PROJECT C
Redoubt Road-Mill Road
Corridor Project

FURTHER INFORMATION RESPONSE – PARKS AND OPEN SPACE MATTERS

The following table responds to the comments made by the Auckland Council Parks team during a site visit on 21 January 2015.

60317081-SHT-30-0000-CD-0514

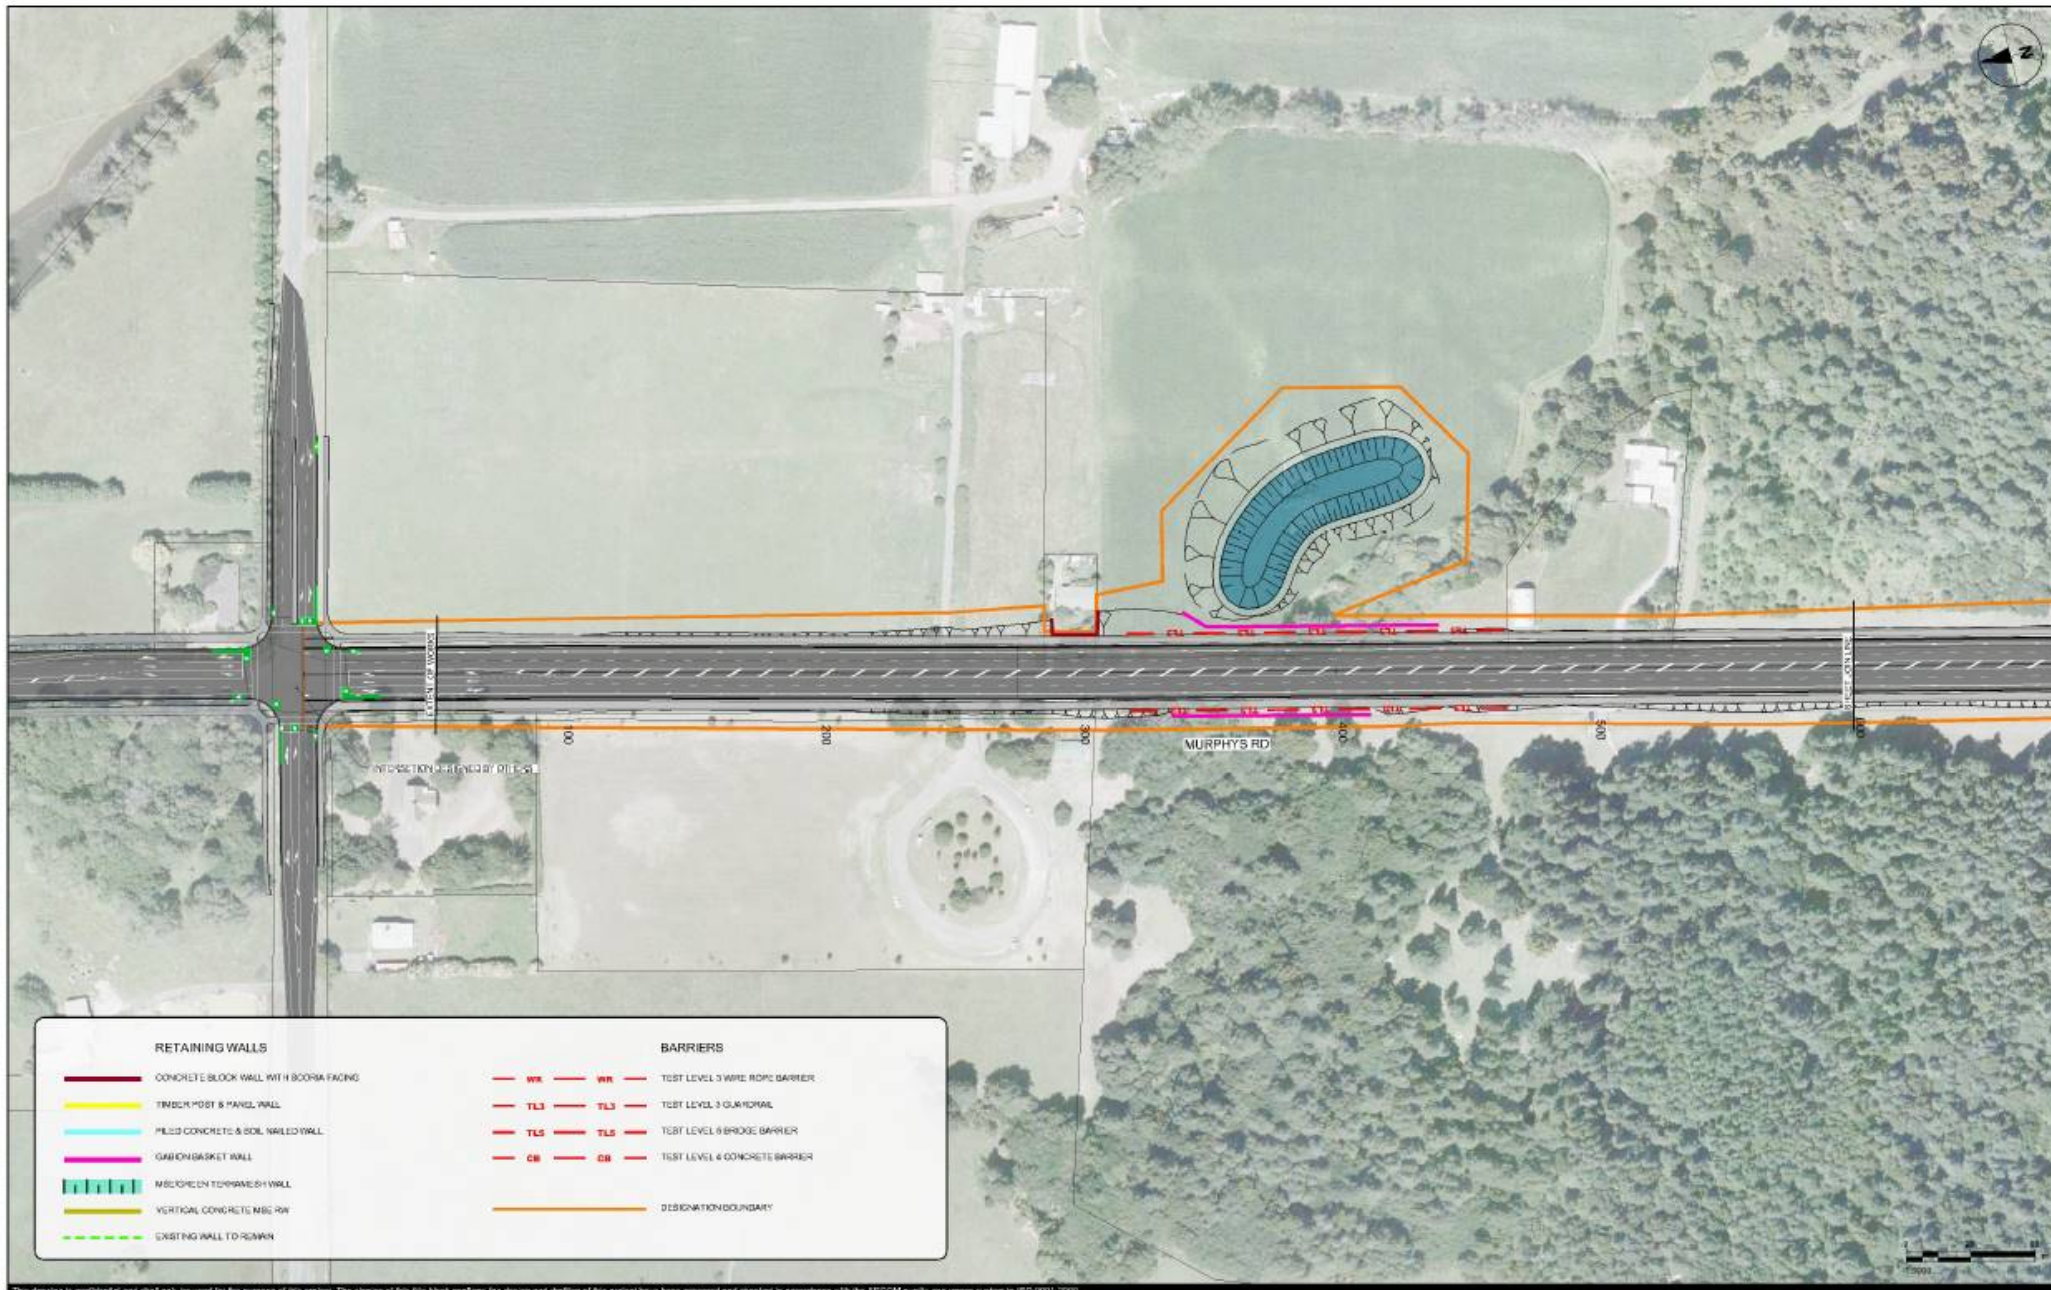
5	<i>How would truck access to the stockyards in Totara Park be managed/maintained?</i>	<p>Drawing 60317081-SHT-30-0000 (attached) shows the access arrangements to the pre-existing farm sheds and stock yard immediately adjacent Redoubt Road. Due to proposed batter slopes in this vicinity, retaining walls will be required to support the proposed vehicle access.</p> <p>The double gated farm access points to the east of 193 Redoubt Road will not be replaced in their current location. An alternative access arrangement will be required. This could possibly be achieved of the main northern access or via the Totara Park Pony Club access. This will be investigated further in consultation with parks as part of detailed design.</p>
6	<i>Will the Pohutukawa trees along Redoubt Road (outside 45-47 Redoubt Road) be removed? Do they have any existing protection under the District Plan?</i>	The row of Pohutukawa trees outside 45-47 Redoubt Road will be removed by the corridor widening. The trees appear over 6m in height and ordinarily would be afforded protection under Schedule 6C of the Manukau District Plan and require consent as a Discretionary Activity for removal. However the application is for a Notice of Requirement seeking to designate the corridor. The effect of a designation is that any work within the designated purpose is not subject to the rules in the operative or proposed District Plans, thus the trees will not require resource consent for removal at a later date.

60317081-SHT-30-0000-CD-0116

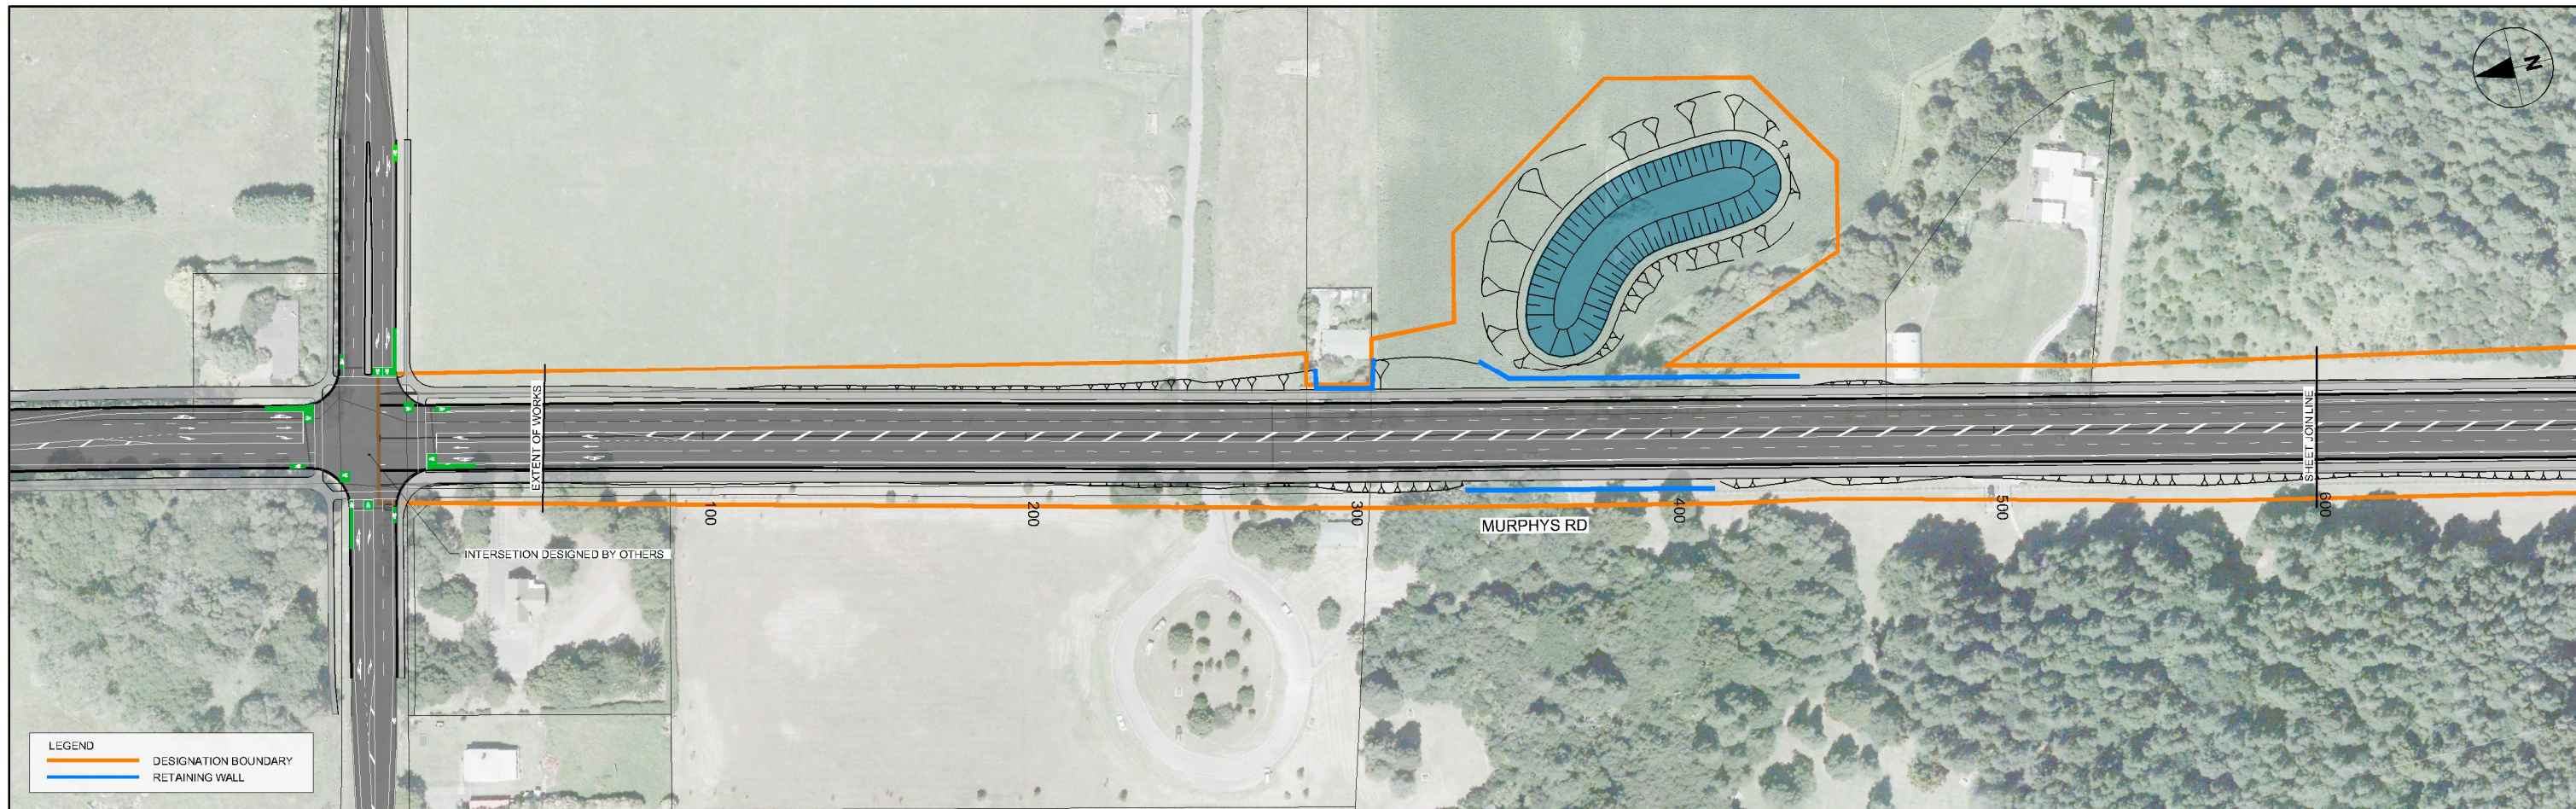
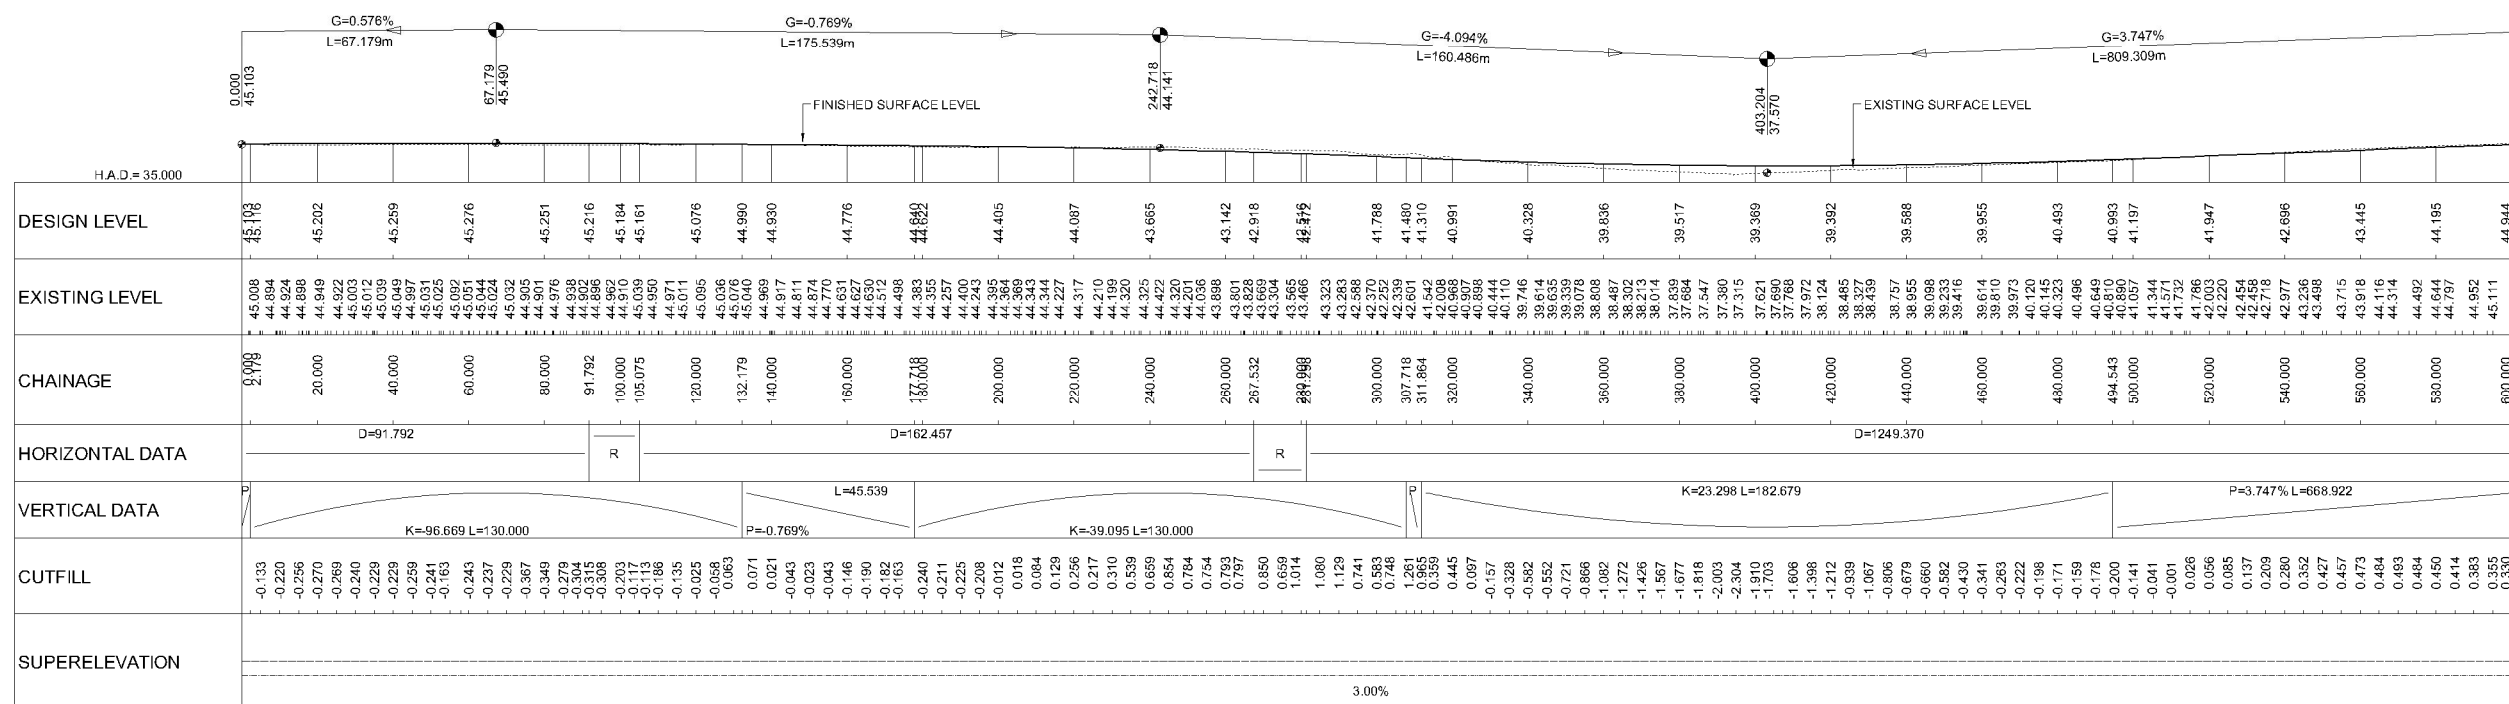
8	<i>Road levels relative to Murphys Bush carparking areas. Will the proposed road levels maintain easy access to Murphys Bush park?</i>	Preliminary road gradients have been designed so that that the road level sits at a similar level to the Murphys Road park entrances (refer attached drawings SHT-30-0000-CD-0116 and SHT-30-0000-CD-0117). The park entrance at the southern edge of Murphys Bush at approximate chainage 740 (refer drawing SHT-30-0000-CD-0117) will require minor re-grading. The proposed designation boundary identified by the orange line on the drawing has been widened at this point to accommodate the minor re-grading works. Following completion of the works, the designation boundary will be pulled back to align with the finished road corridor.
9	<i>Parks to be provided a copy of the updated Heritage assessment which has more detail around St Johns Redoubt.</i>	A copy of the revised Heritage assessment has been forwarded to the Parks Team.
